ANNEXURE G:
GEOTECHNICAL REPORT

**REPORT ON:
GEOPHYSICAL GROUND CONDITION SCREENING**

**PROJECT:
HAREWOOD CAR STORAGE YARD**

**Re: Car Distribution Group Yard – 711 Johns Road
Response to CCC Request for Information, RMA/2017/765**

Figure 3.3 – Noise emissions during a peak night time period when trucks leave the site

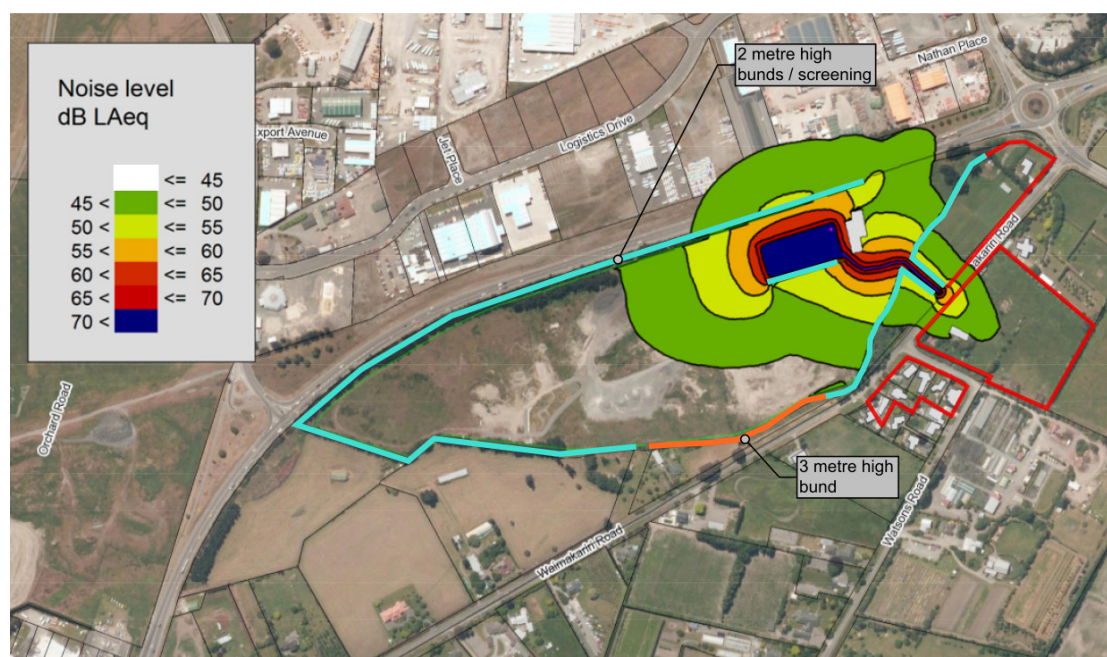
3. *Please confirm the reason for the houses to the west of Watsons Road e.g. 91 Watson being shown bounded in red in Figure 3.3.*

The houses are bounded red as during the peak night time period (a 15 minute period from 4 am), noise levels at the notional boundary of the dwellings on these properties will exceed 40 dB L_{Aeq} which is the District Plan night time noise limit.
